AFS M-2014-043 Hatchery Adequacy Response

RE: Albert Frei and Sons, Inc.
Hatchery Pit - M-2014-043
Technical Revision 01 adequacy response 01

CONSTRUCTION PLANS FOR
HATCHERY PIT PHASE 2 SLOPE LINER
ADAMS, COLORADO

Pipeline Drains Overall Plan

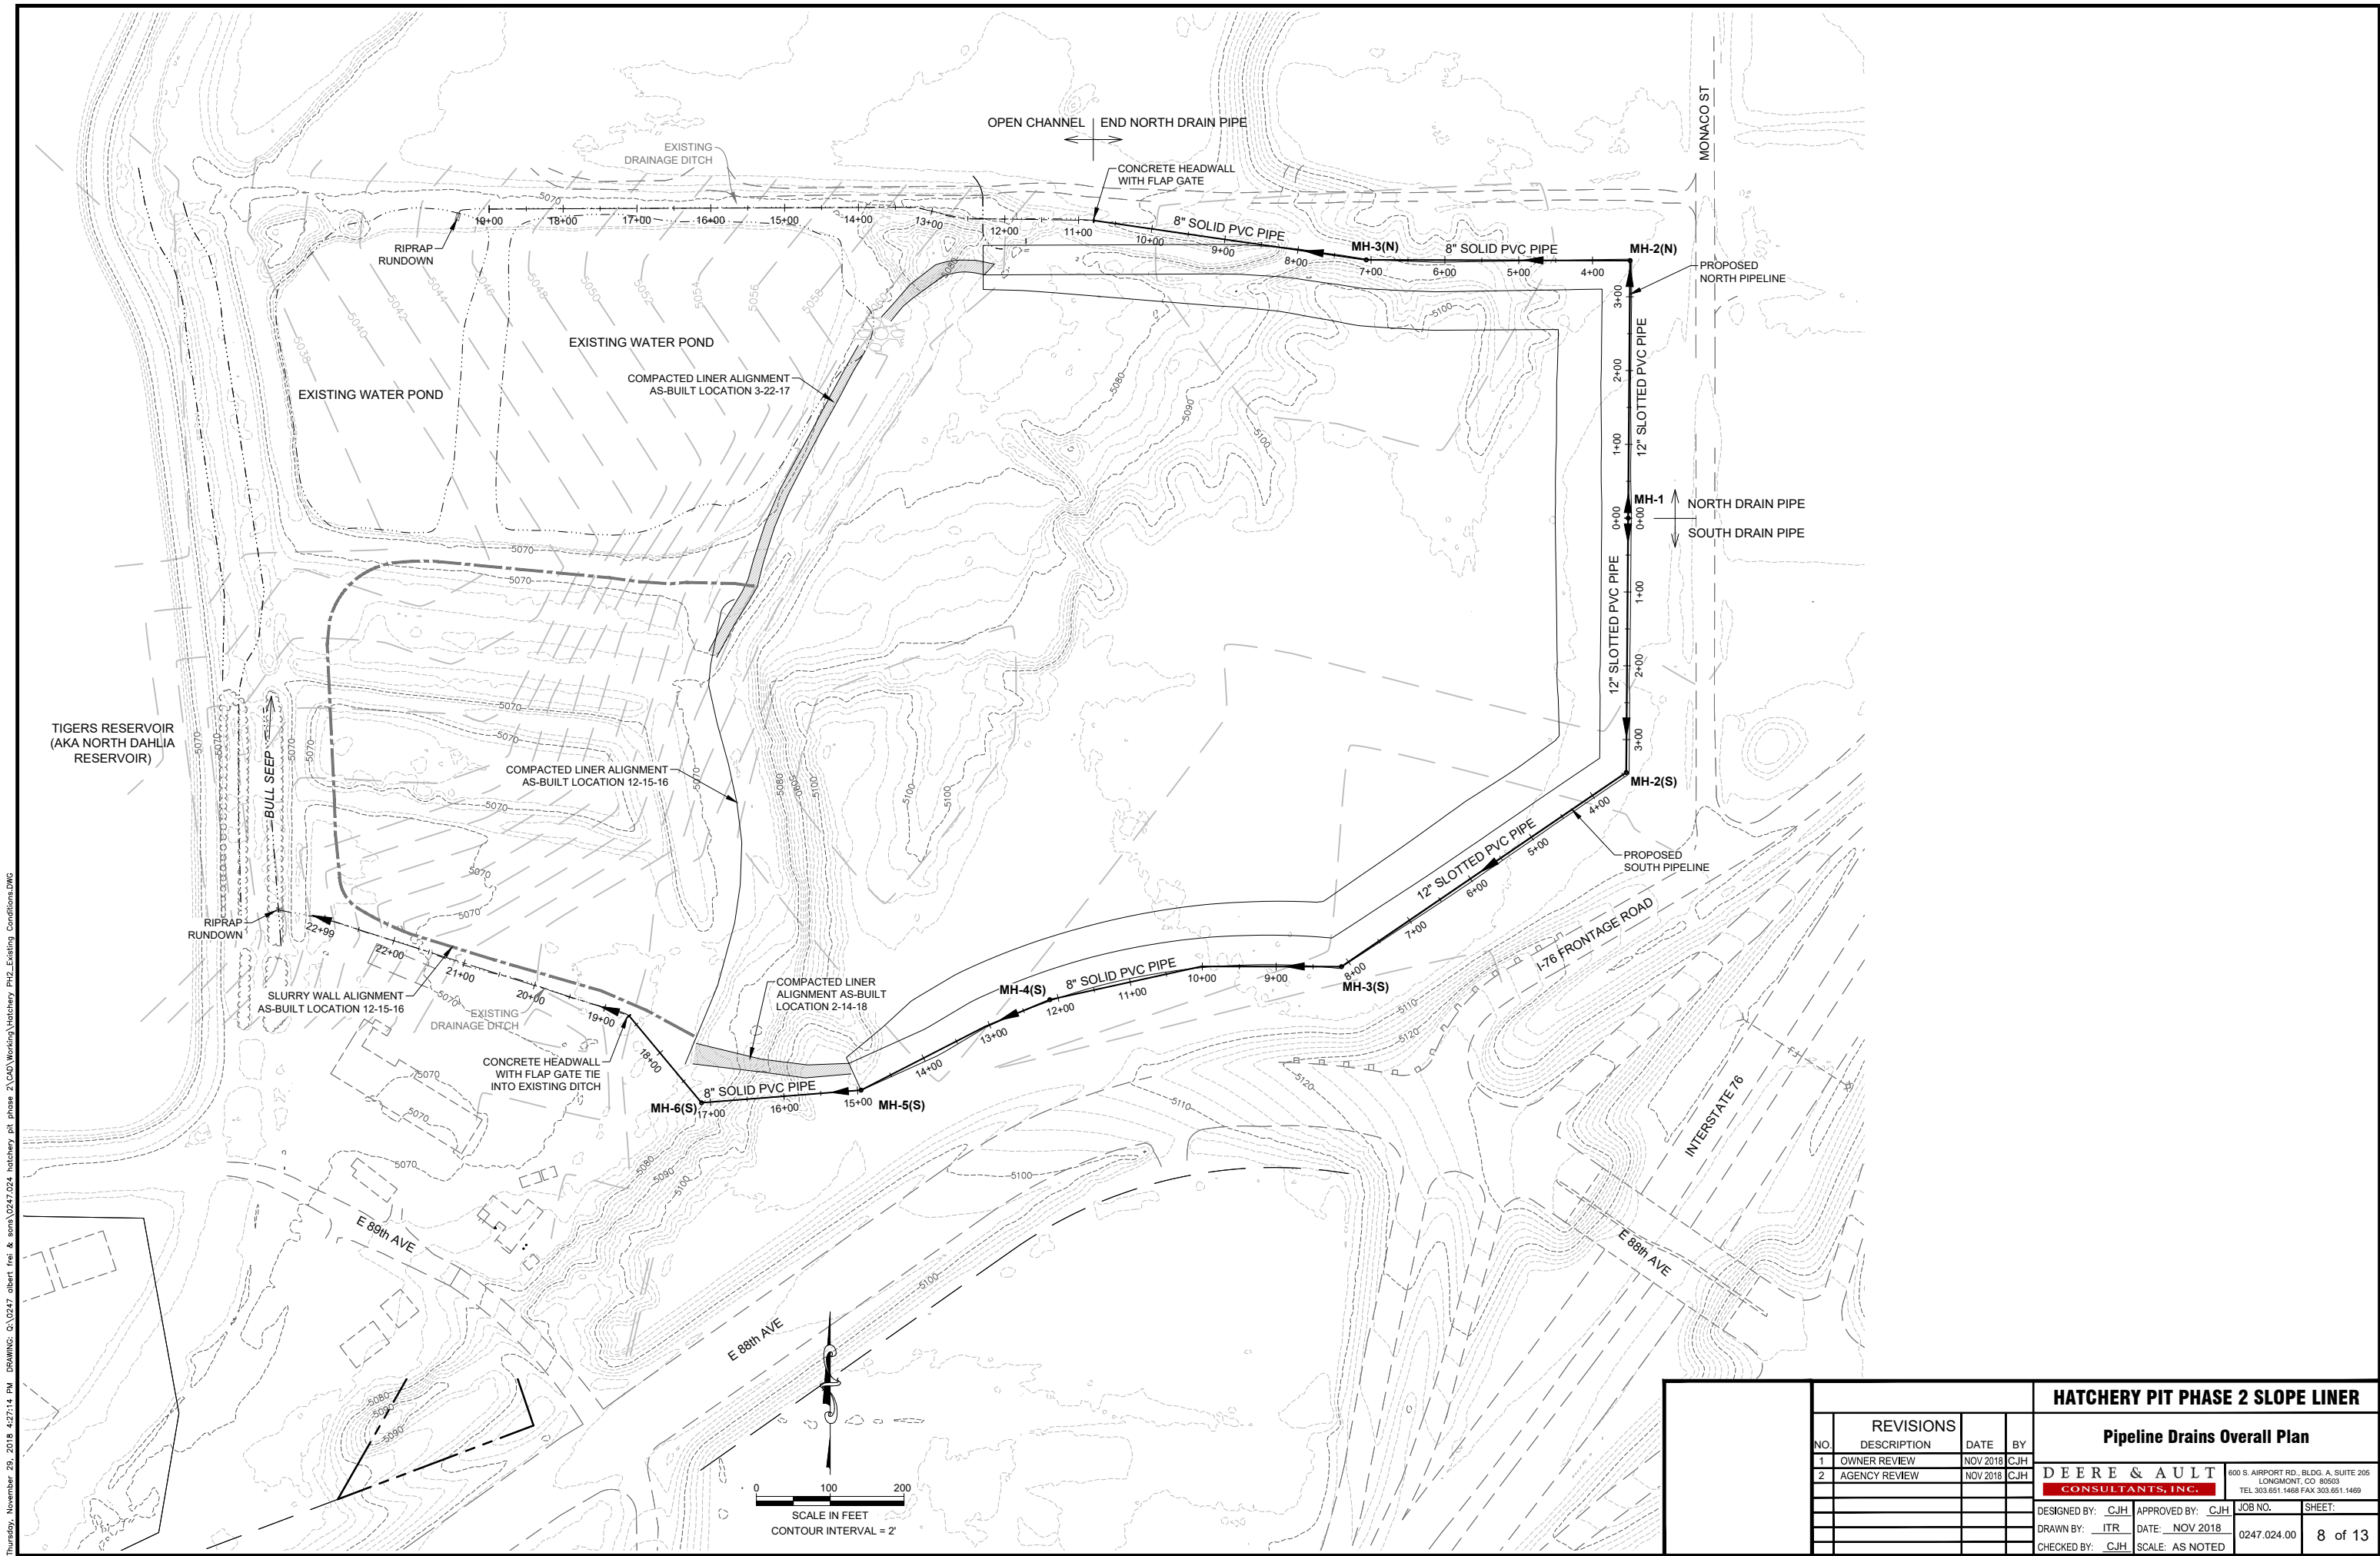
The plans call for installing 8 manholes along the french drain approximately every 300 feet that will provide access to the drain for inspection and clean out if necessary. Details are shown in the Deere & Ault design Plat, page 13 of 13 and the approximate locations are shown on pages 8 of 13.

This information is shown in the Deere & Ault report on Plat pages 8 of 13 thru 12 of 13. As designed the pipe will a 0.5% slope from the high point to the outlets.

North Pipeline Plan and Profile

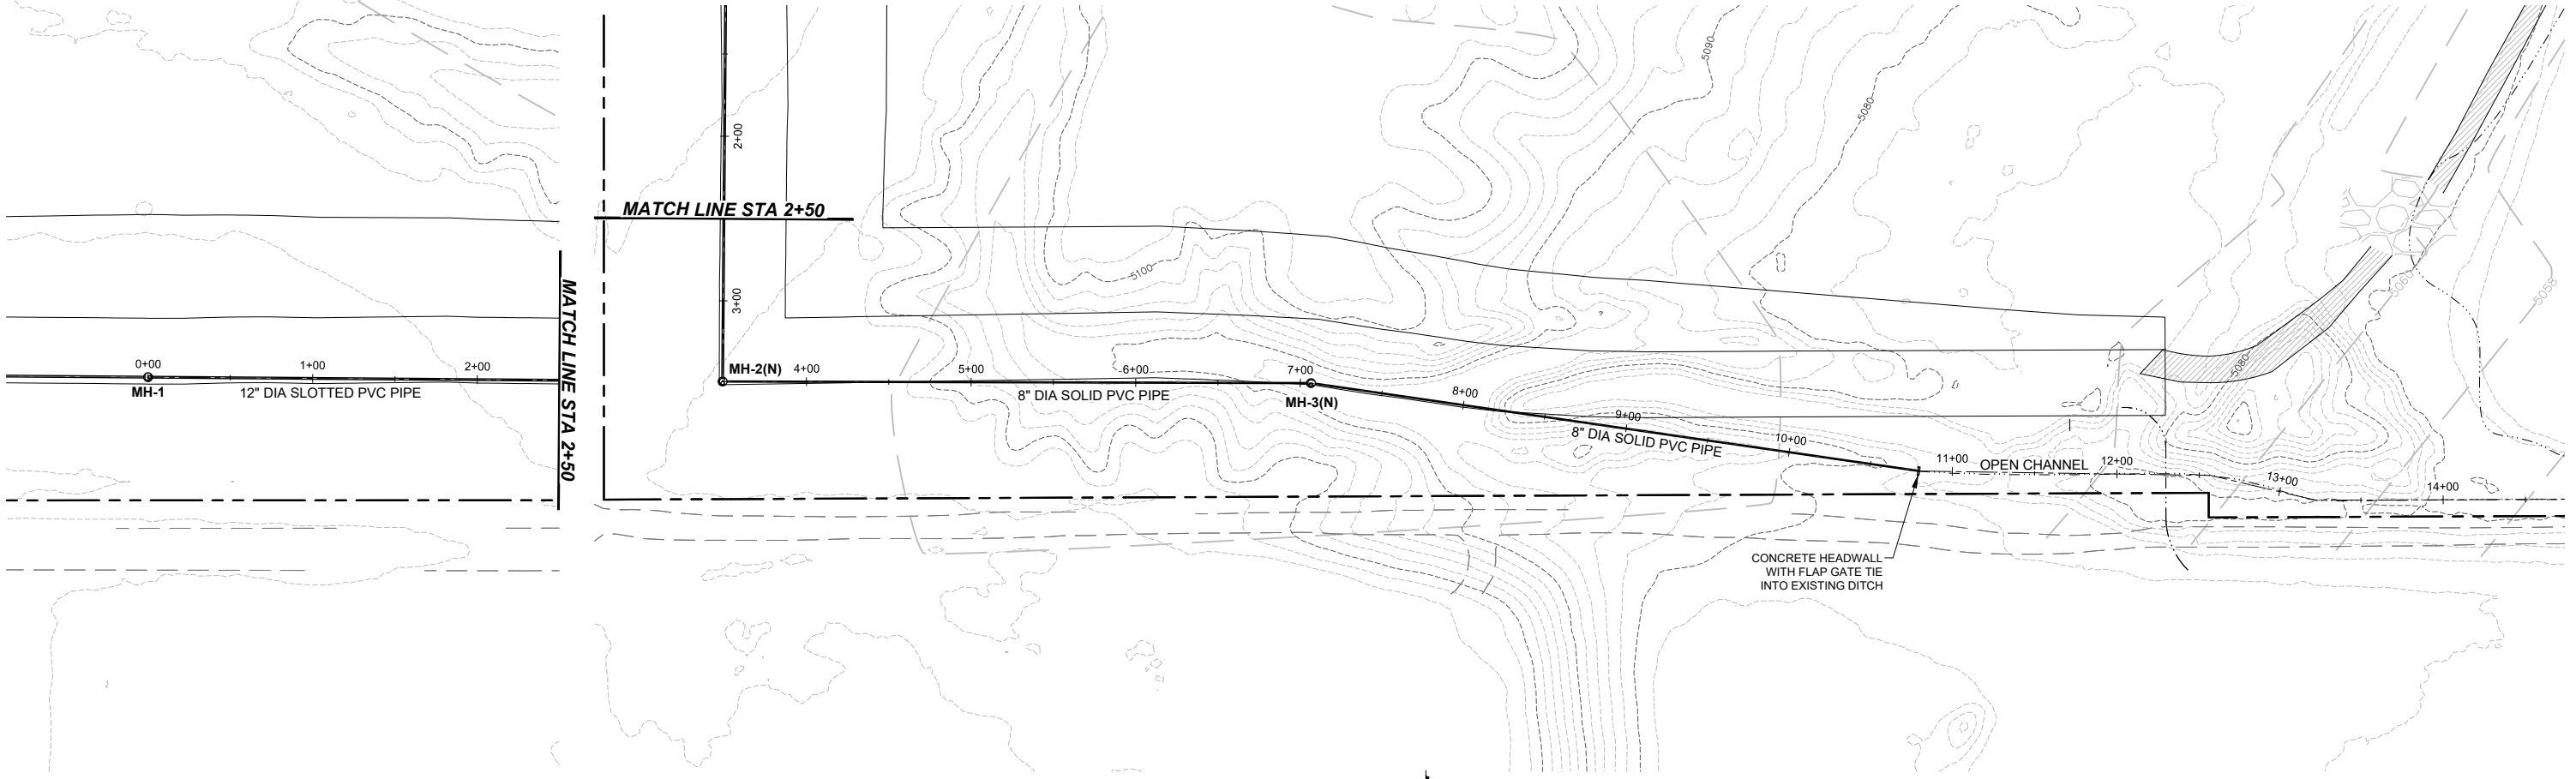
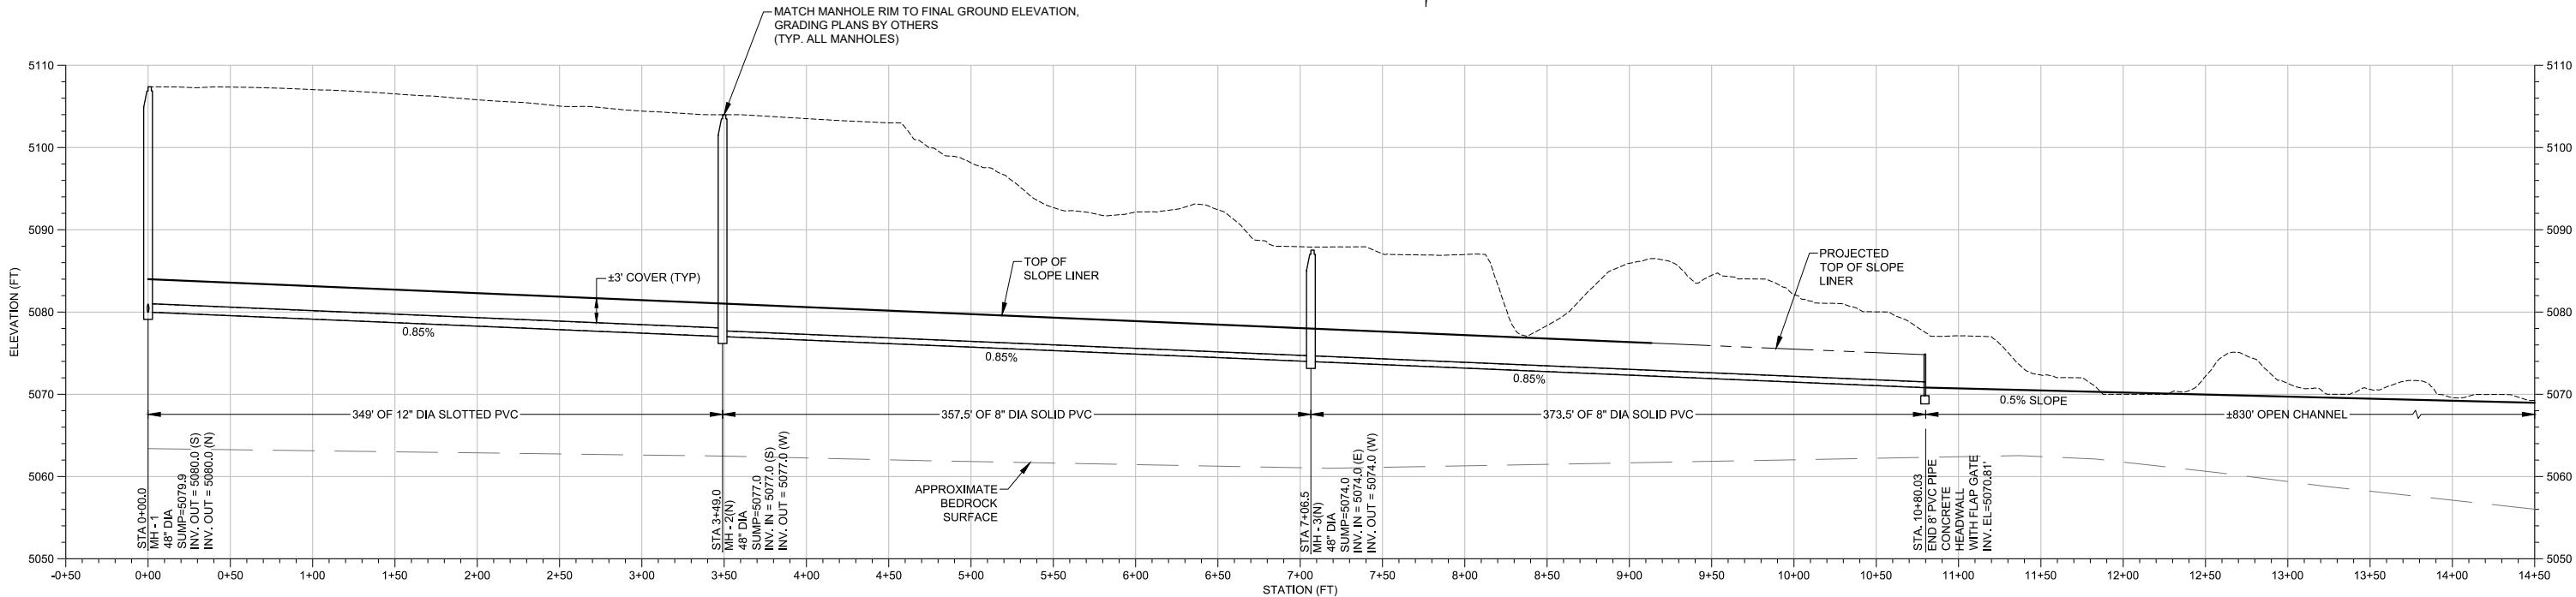
- c. Please provide a profile for the pipe and demonstrate how it will positively drain.

Details

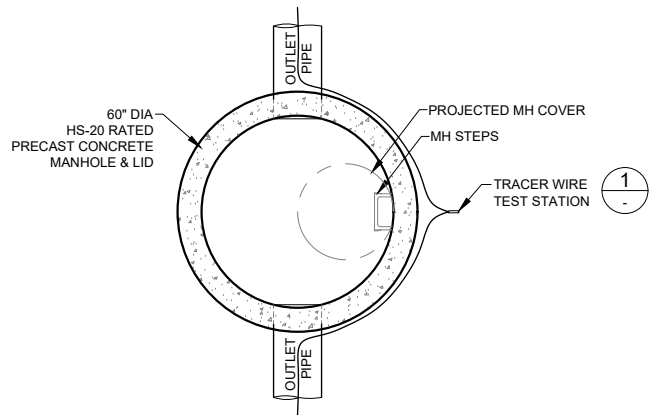
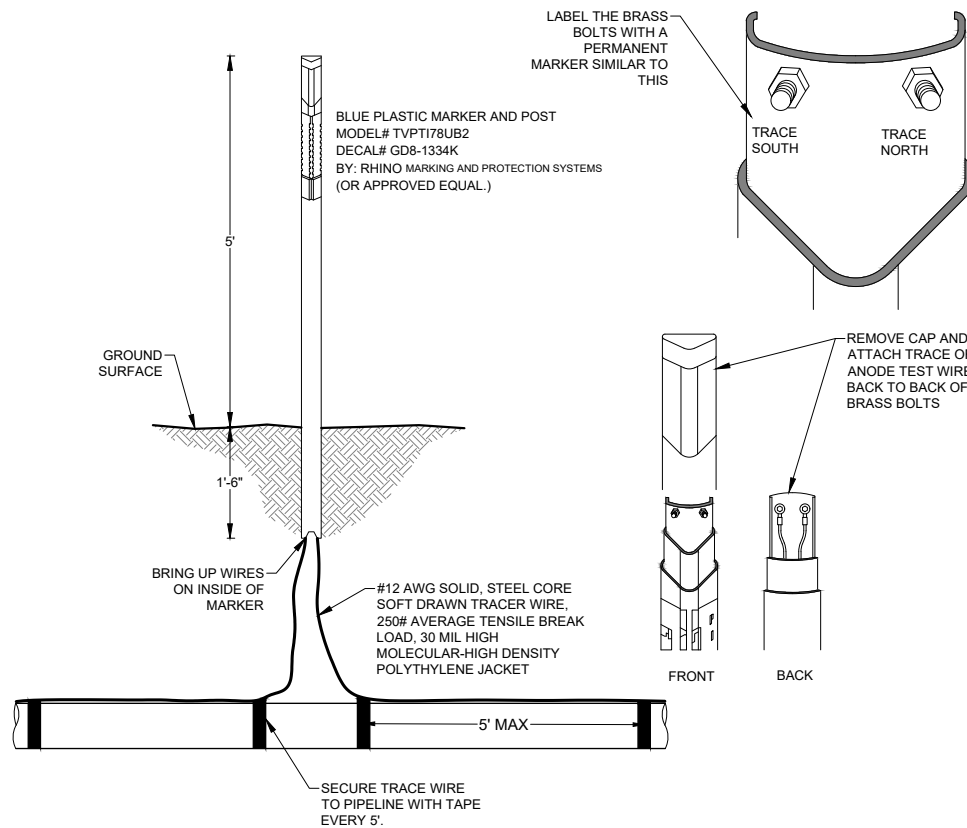
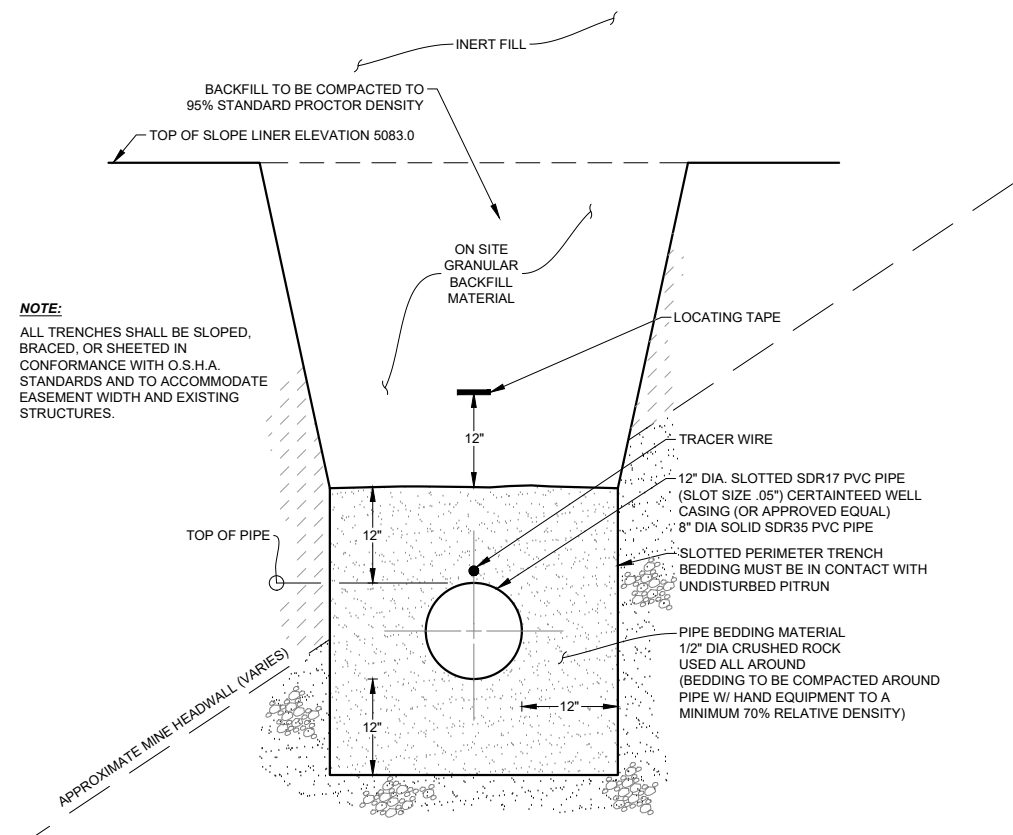
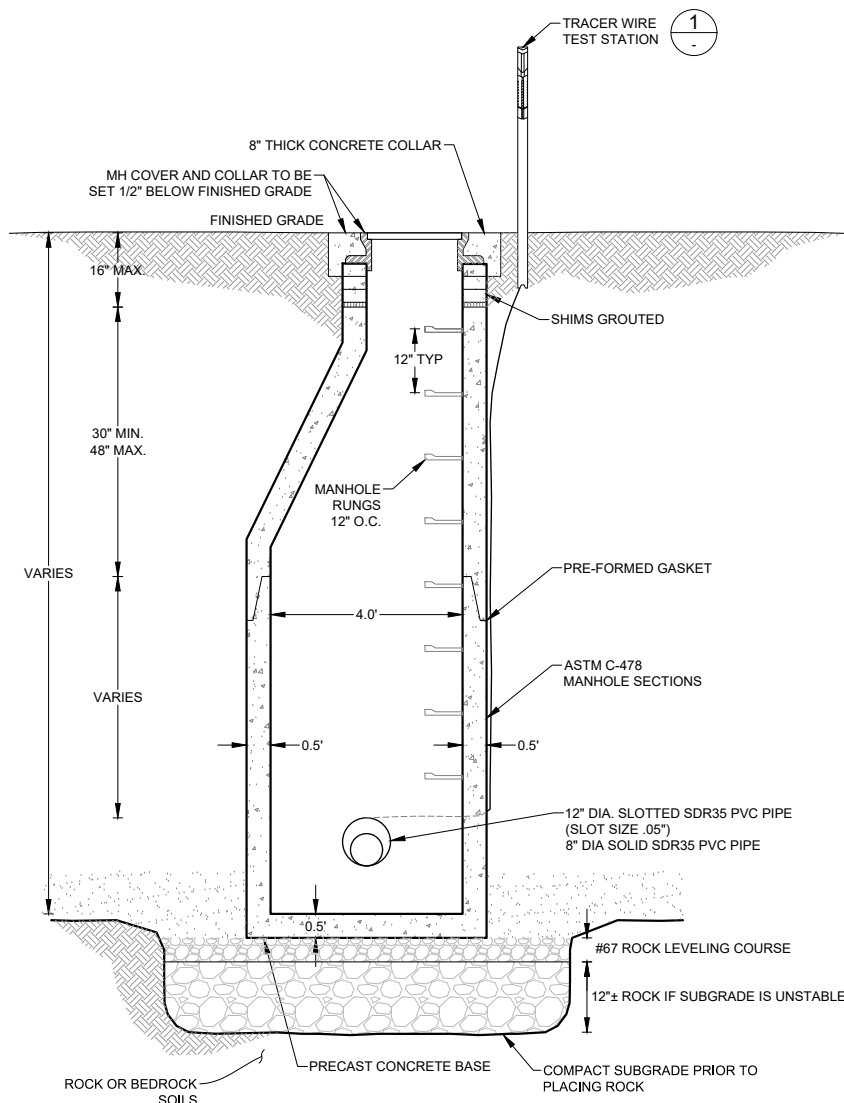
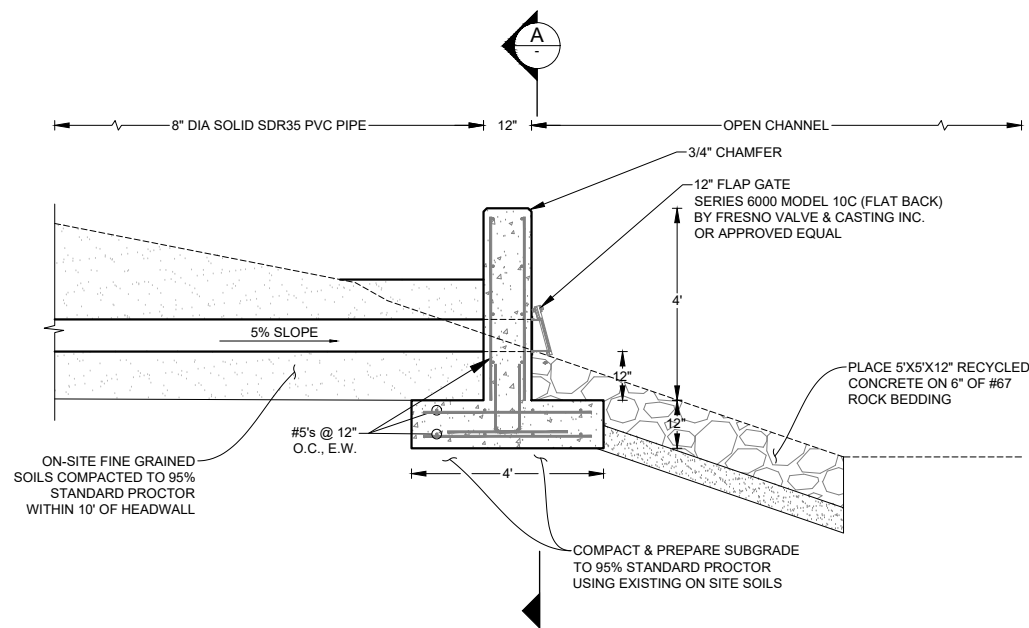
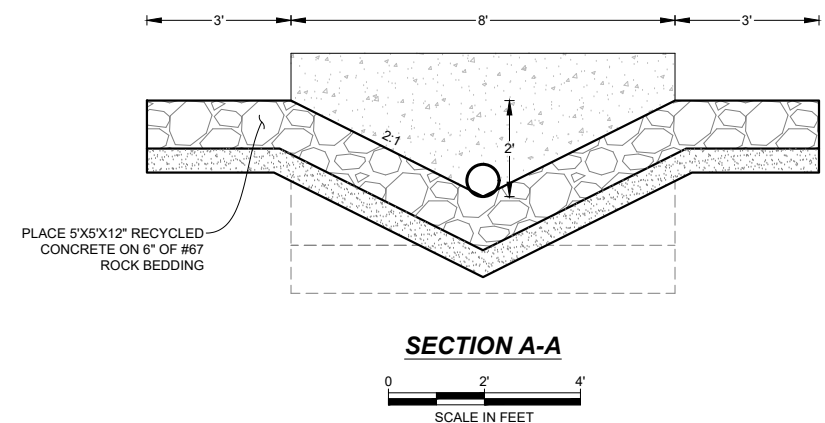
Deere & Ault determined that a 12 inch pipe will be adequate to convey the ground water around the fill. Their plans show the typical french drain trench detail on plat page 13 of 13. Albert Frei and Sons, Inc. has decided to use 14 inch perforated pipe and 12 inch solid drain pipe as a factor of safety.
